Former Robert Bateman High School –parking options EICS-12-23

To: CPRM Committee

September 12, 2023

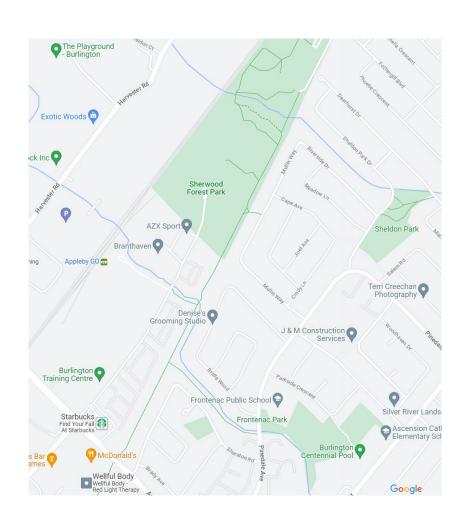
This report says that CoA makes the decision.

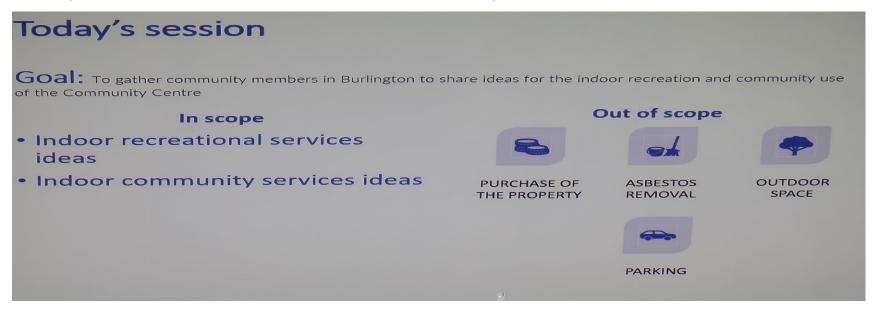
Who checked this?

No need to lease parking space till 2025.
